# **S.L CHASSE STEEL SITE PLAN**

SP# 01-23

## **STAFF REPORT**

Re: Town of Hudson Planning Board Review  
SL Chasse Steel Site Plan, 5 Christine Drive  
Tax Map 105 Lot 14; Acct. #1350-532  
Reference No. 20030249.2260

**CONCRETE WALK DETAIL**  
NOT TO SCALE  
(MARCH 2008)

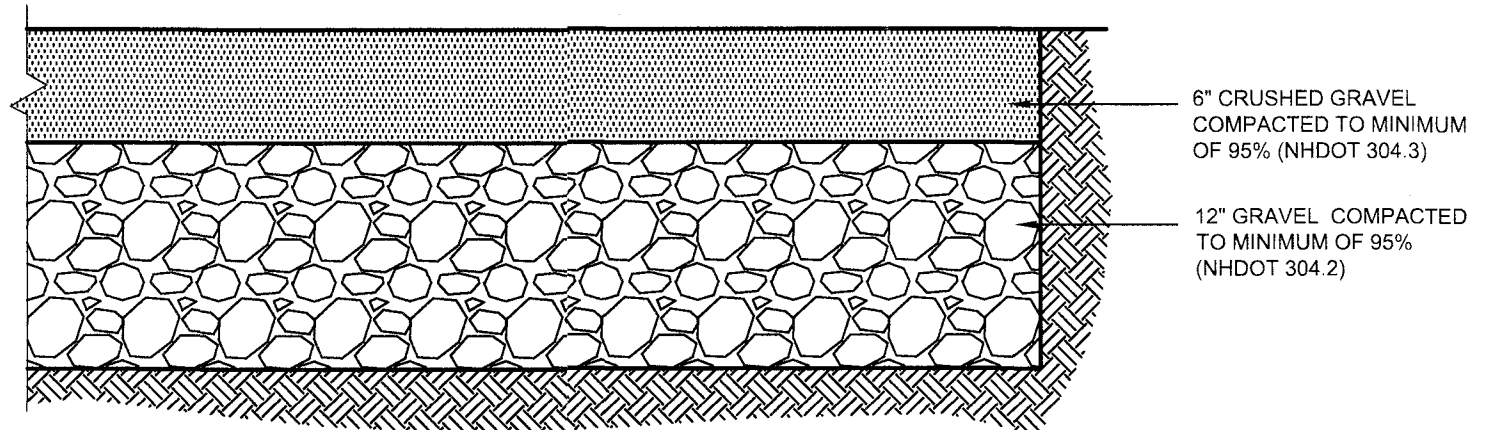
- The applicant has not provided adequate grading information for the proposed concrete walk that surrounds the building. No curb ramp locations are shown on the plans, and it's not clear from the concrete walk detail if this is intended to be flush with the parking lot pavement or elevated. The applicant should provide more information as to the intent of the walk and provide adequate handicapped accessibility as needed.  
*The applicant responded that the concrete walk is designed to be flush and is now called out as such on Sheet 4.*

- g. **Former/Current Fuss & O'Neill Comment:** HR 275-9.C.(11). The applicant has provided two handicap accessible parking spaces for the site which meets the minimum requirement. We note that the applicant has not provided adequate grading information for the proposed concrete walk that surrounds the building. No curb ramp locations are shown on the plans, and it's not clear from the concrete walk detail if this is intended to be flush with the parking lot pavement or elevated. The applicant should provide more information as to the intent of the walk and provide adequate handicapped accessibility as needed.

*The proposed concrete walk is designed to be flush and is now called out as such on sheet 4 of the revised plans.*

**TYPICAL BIORETENTION POND SECTION**

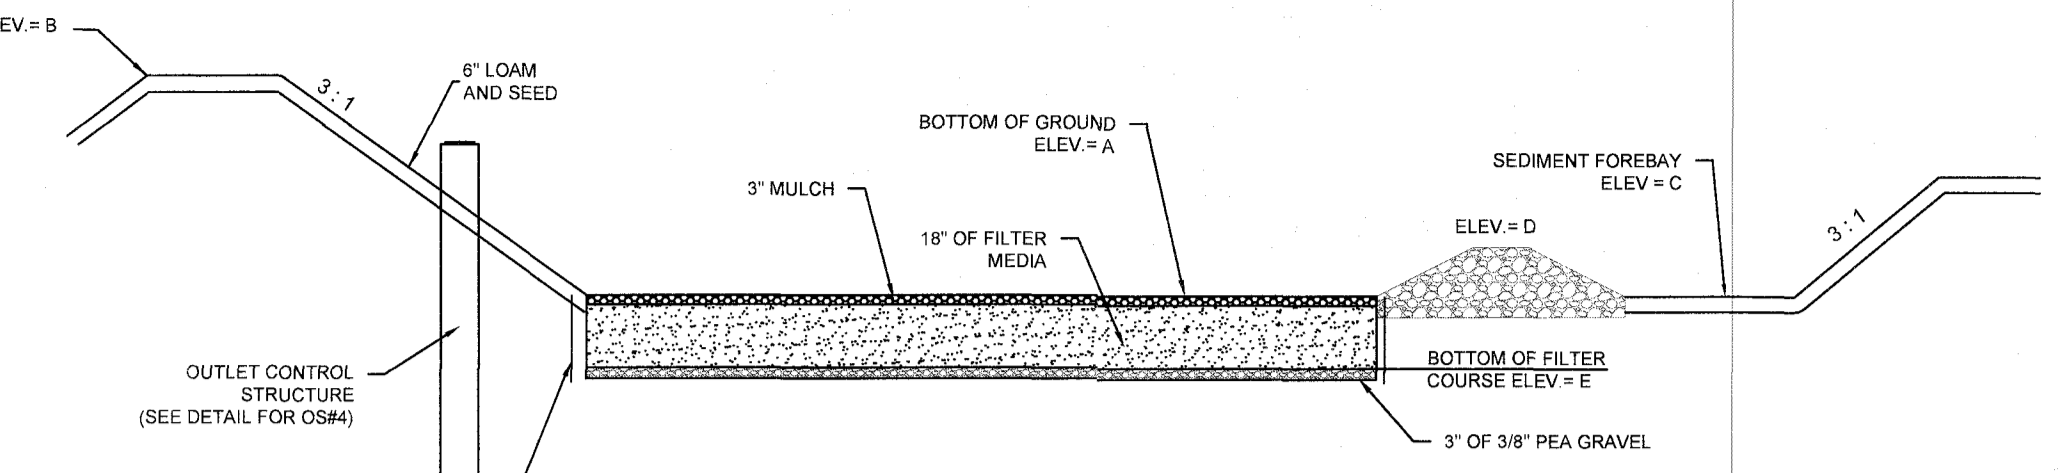
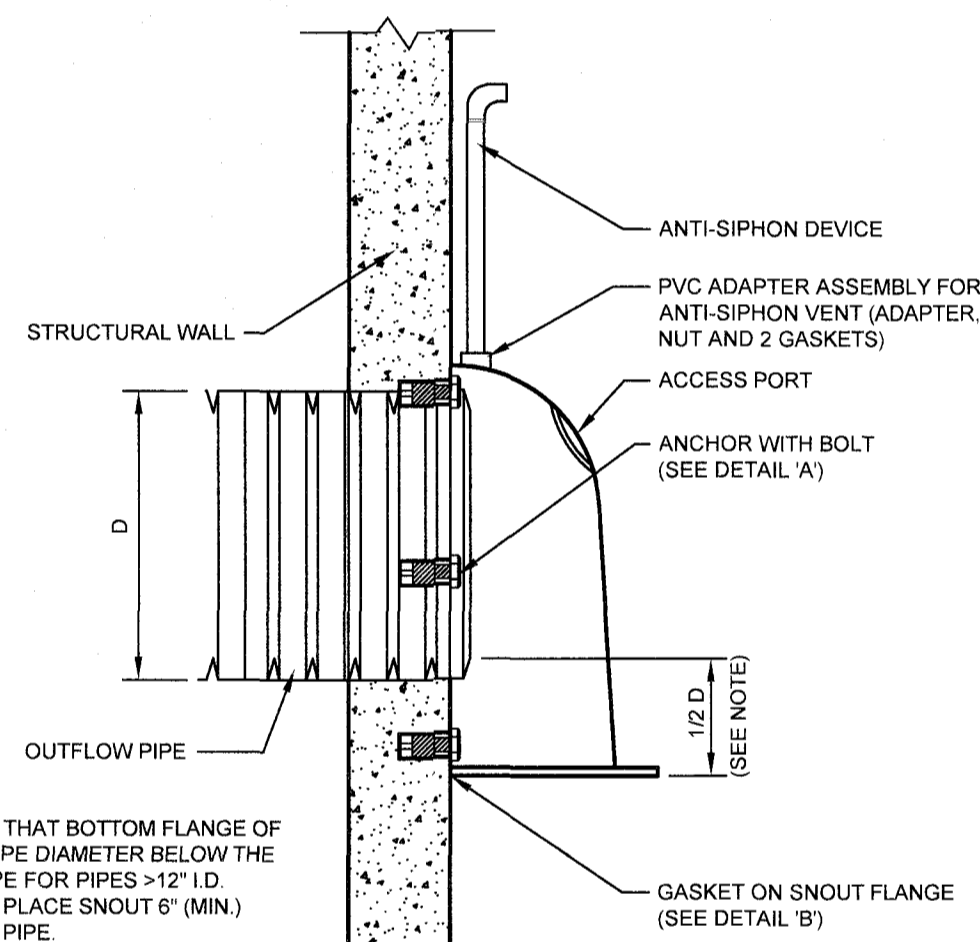
- g. *Former Fuss & O'Neill Comment: HR 290-6.A.13. The Typical Infiltration Pond Section detail on plan sheet 10 notes the bottom of the basin to have "pea stone and amended soils". The applicant should provide additional information on the proposed depth and gradation/ type of pea stone and amended soils proposed.*

Current Fuss & O'Neill Comment: The applicant has revised the design to no longer use amended soils. We note that due to the ongoing cost of materials inflation and supply chain issues, we have experienced contractors requesting readily available and more cost-effective alternatives from manmade impervious liners, like the project is proposing. We have started adding an alternative option of "minimum of 6 inch" clay liner to meet specs of NHDOT Item 203.53 – Low Permeability Fill, with a maximum saturated conductivity of 0.03 ft/day (0.01 in/hr). Compacted to at least 95% maximum dry density." This has been coordinated with NHDES AoT and was an approved alternative on a former project. No further Fuss & O'Neill comment.
